ADDENDUM NO.: 1 JULY 10, 2015 FEDERAL BUILDING ARVIAT, NUNAVUT

Parkin Architects Limited 20 James Street, Suite 200 Ottawa, Ontario, K2P0T6

1.1 <u>ADDENDUM</u>

MAIN FLOOR CONTROLS PLAN

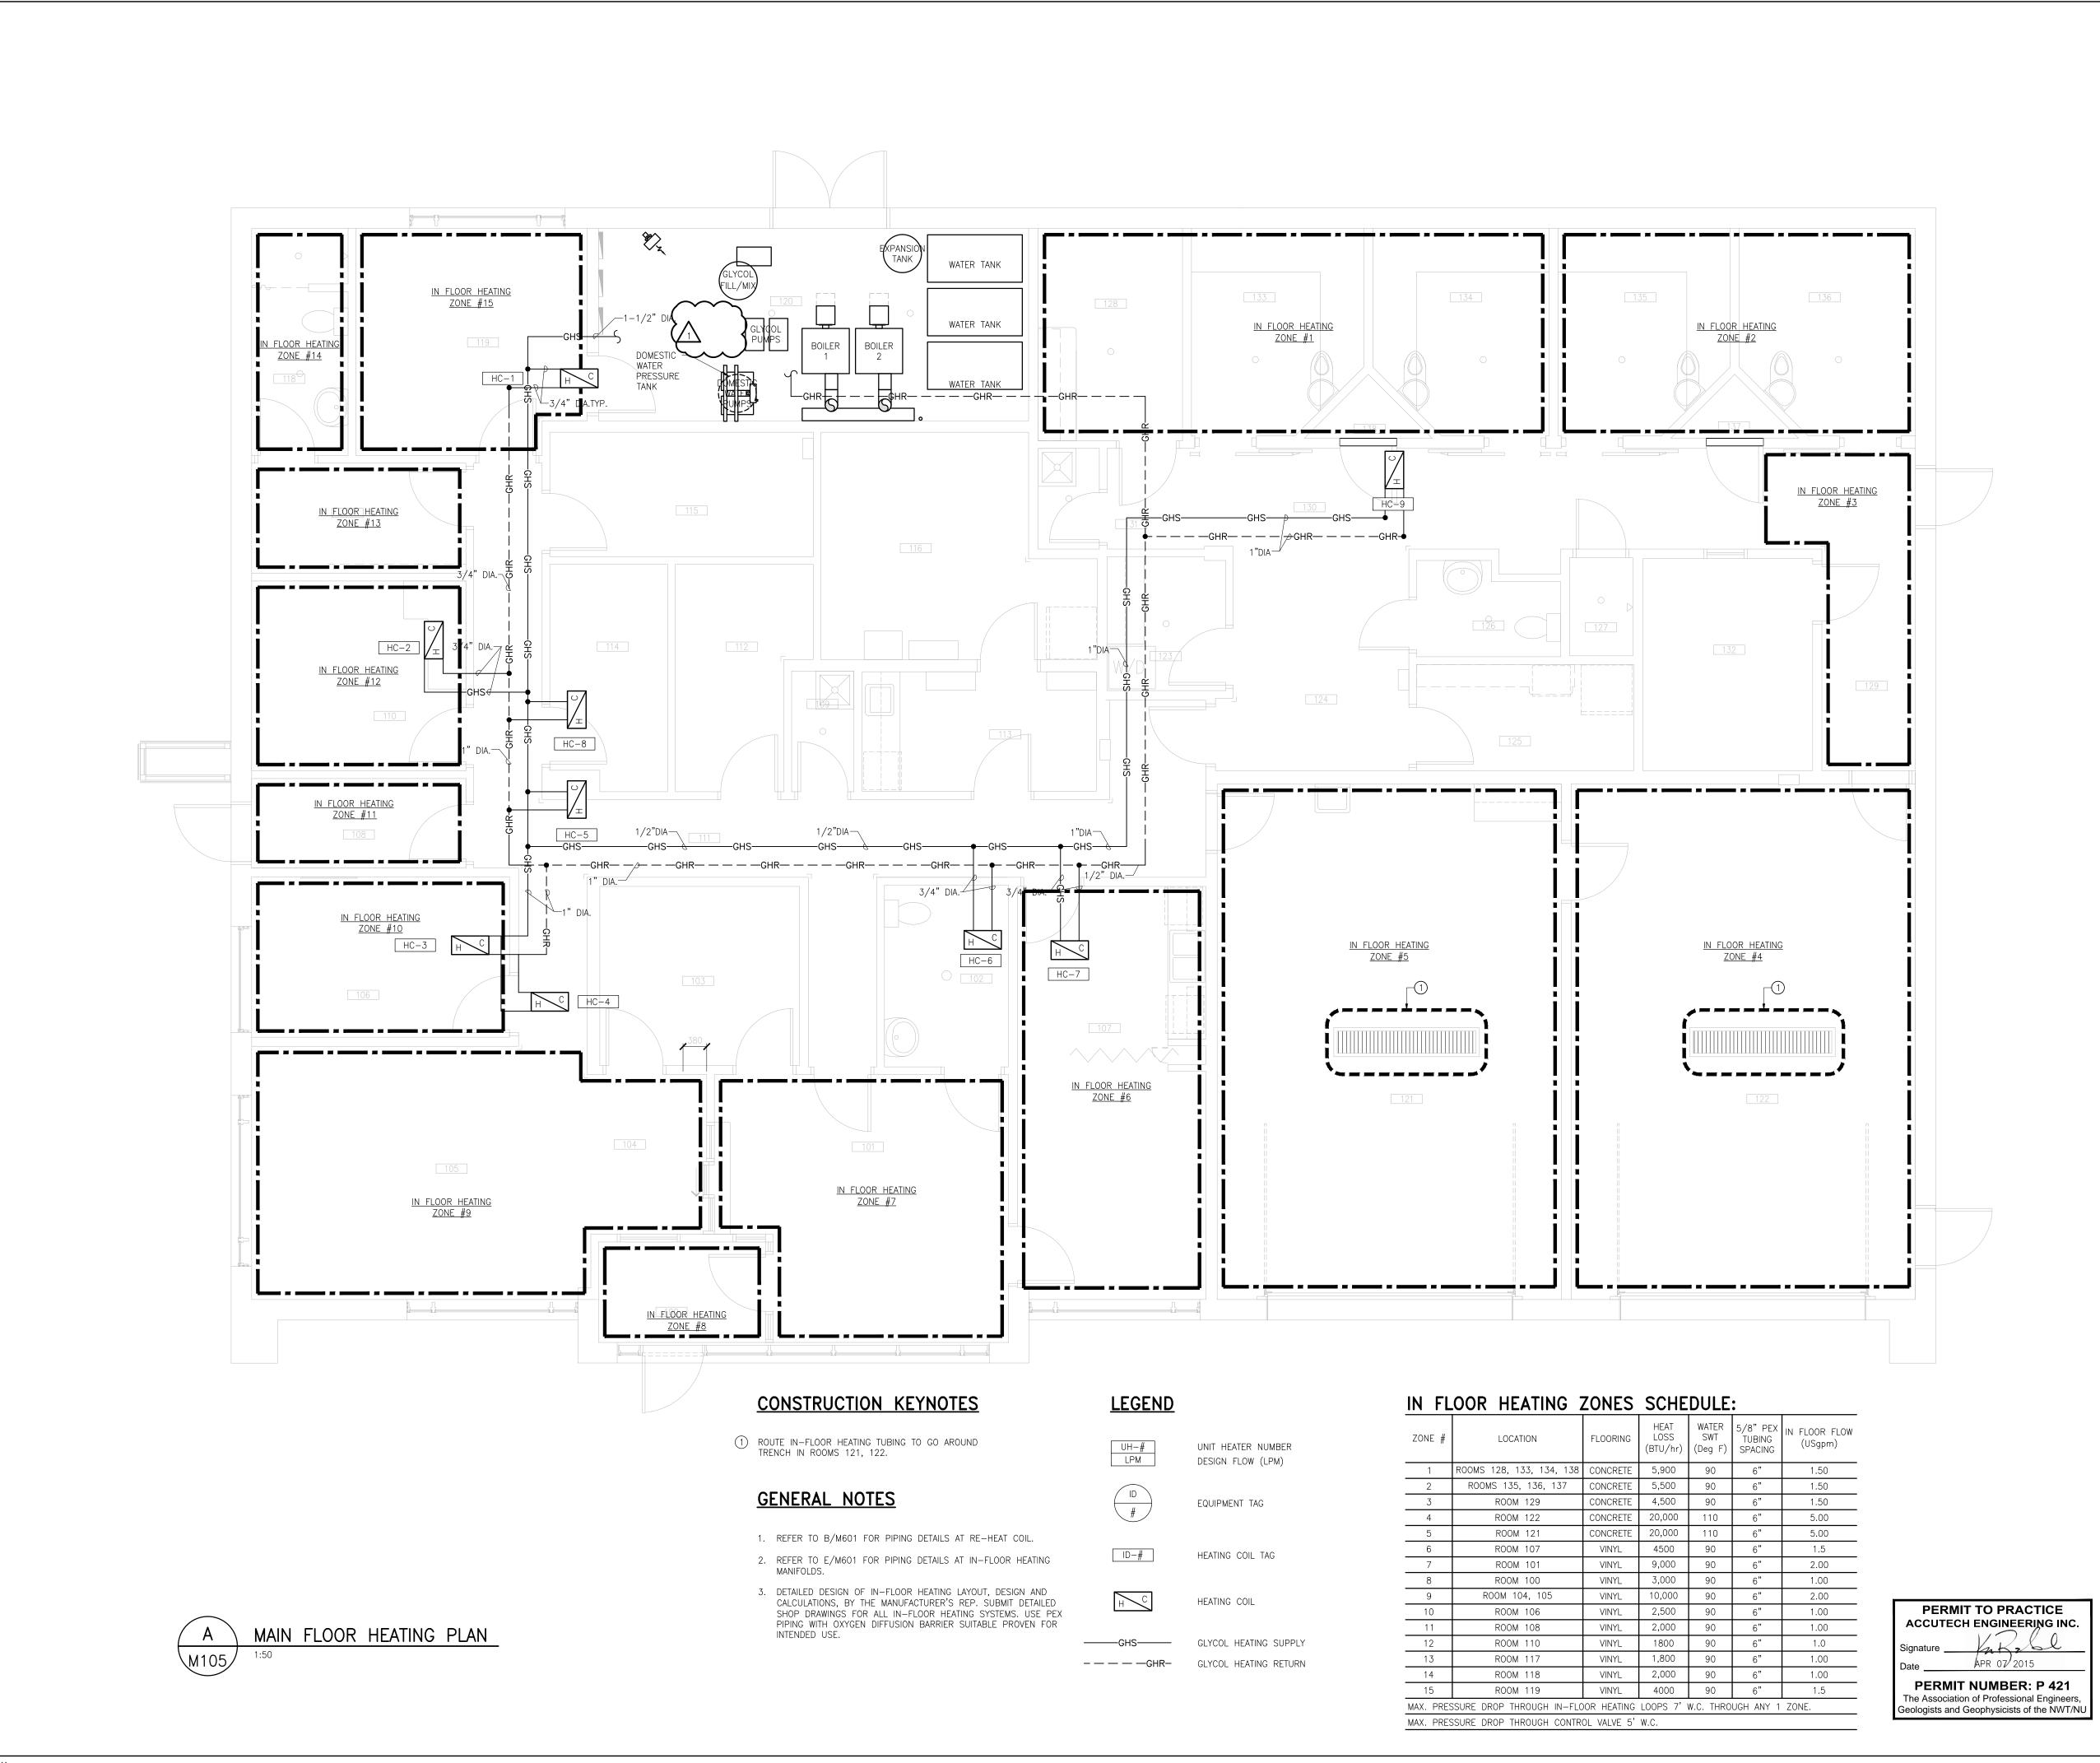
1.4.3. ROOM 133, 134, 135, 136 ARE TO BE REMOTELY CONTROLLED BY MANUAL SWITCH AT WORK STATION IN ROOM 130 (ONE PER ROOM). LOCATION SHOWN ON DRAWING: SEE KEYNOTE 10/M103
- 1.4.3.1. S/A AND E/A DAMPERS FOR EACH ROOM TO BE INTERLOCKED TO
 ALLOW E/A AND S/A AIR TO BE REMOTELY CONTROLLED IN UNISON.
 POSITION FOR S/A AND E/A DAMPERS TO BE NORMALLY CLOSED.

1.4.3.2. MOTORIZED DAMPER IN 350×300 E/A DUCT TO MODULATE IN ORDER
 TO PROVIDE 470 I/s CONTINUOUS AIR TO EF-1. TO BE CONTROLLED
 BY PRESSURE TRANSMITTER AT FAN INLET. DAMPER TO BE NORMALLY
- .5. SCHEDULING TEATURES REQUIRED FOR EACH SPACE/20ME
